August 29, 2001
NOC-AE-01001163
STI: 31336863

South Texas Project
Units 1 and 2
Docket Nos. STN 50-498, STN 50-499
Response to NRC Bulletin 2001-01,
“Circumferential Cracking of Reactor Pressure Vessel Head Penetration Nozzles”

**Response to NRC Bulletin 2001-01
Circumferential Cracking of Reactor Pressure Vessel Head Penetration Nozzles**

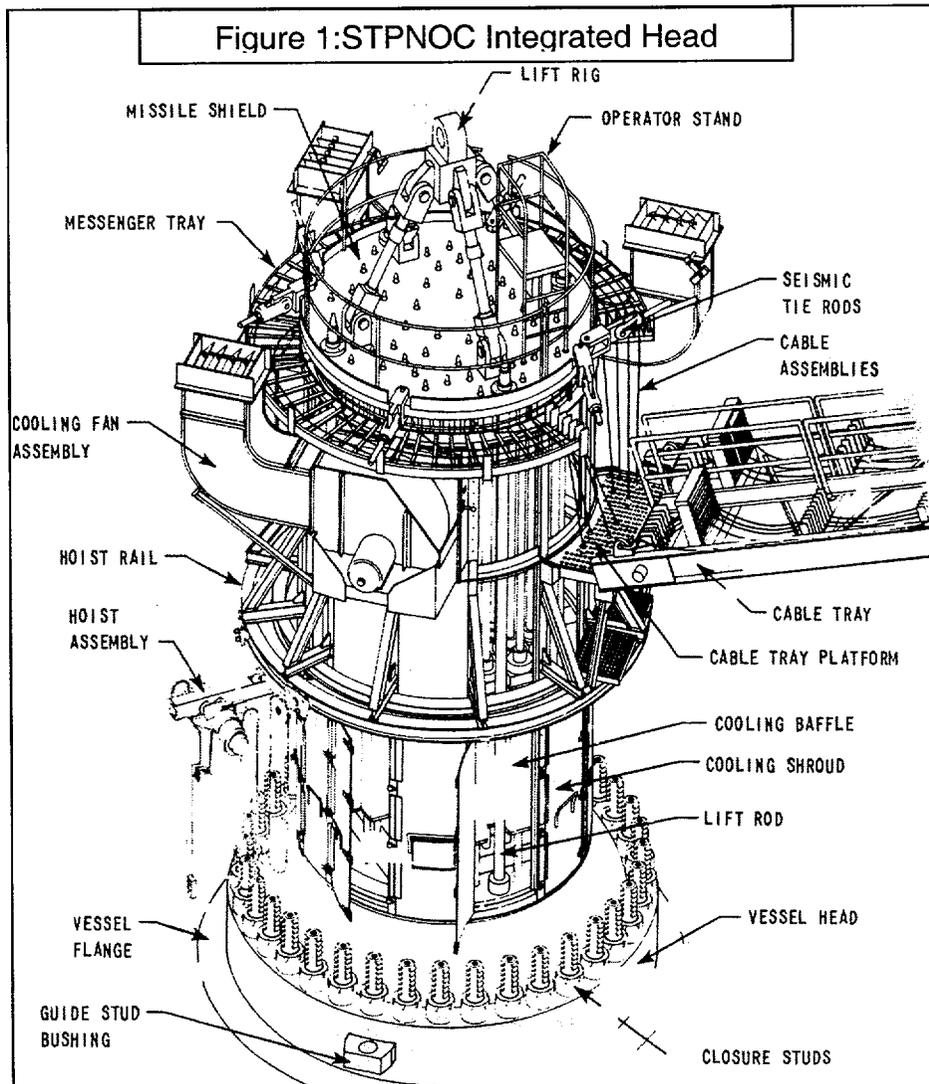
- e. a description of the configuration of the missile shield, the CRDM housings and their support/restraint system, and all components, structures, and cabling from the top of the RPV head up to the missile shield. Include the elevations of these items relative to the bottom of the missile shield.**

Table 1 provides relative elevations of various significant components to the missile shield. The STP integrated head package consists of the head lift rig, missile shield, seismic supports, control rod drive mechanisms (CRDM), CRDM cooling system, and the power and instrumentation cabling. Figure 1 shows the assembled system attached to the reactor vessel head.

Reactor Missile Shield	The missile shield is a circular, steel plate attached to three lift rods that extend down to the reactor vessel head. The shield is laterally supported by six seismic tie rods attached to the reactor cavity wall. The missile shield may be detached to provide access to the CRDMs. In addition to providing containment for missiles that may be ejected from the head, it also provides seismic support for the CRDMs and serves as a spreader for the head lift rig.
CRDM Cooling Shroud	The CRDM Cooling Shroud is a generally cylindrical steel structure that maintains a suitable atmosphere for the CRDMs in order to protect and prolong the life of the CRDM coils. The CRDM cooling shroud encircles the RPV head insulation and impedes access to the insulation panels.
RPV Head Penetrations	There are 79 RPV head penetrations. Seventy-six (76) of these penetrations are J-groove welded RPV head penetrations, of which 74 are the CRDM type penetrations. Of these 74 penetrations, 57 penetrations are used for the CRDMs, four (4) penetrations are spares mounted with capped latch assembly housings, seven (7) penetrations are spares capped with female flanges, two (2) penetrations contain instrumentation for the Reactor Vessel Water Level System (RVWL), and four (4) penetrations contain thermocouple connections. The two (2) remaining J-groove welded RPV head penetrations are for the head vent and the degasification line. The three (3) remaining penetrations are OD butt welded penetrations containing the internals support housing lift rods.

CRDMs	The CRDMs are located on the dome of the reactor vessel. The CRDM consists of four separate subassemblies. They are the pressure vessel (housing), coil stack assembly, latch assembly, and the drive rod assembly. The CRDM pressure vessel is connected by a seal-welded threaded connection to the CRDM RPV head penetration and restrained at the top by the missile shield. The other CRDM subassemblies are external to the CRDM pressure vessel and provide for withdrawal or insertion of the rod control cluster assemblies (RCCAs), and for RCCA position indication. All power and instrumentation cable assemblies traverse up from the head penetration components to the messenger tray out to the cable tray.
RPV Head Insulation	See response to 1.c.
CRDM RPV Head Penetrations	The CRDM RPV head penetrations provide a pressure boundary from the RPV to the threaded seal-welded connection for the CRDMs. The penetrations are structured to provide a uniform height transition from the round reactor vessel dome to the CRDM housing.
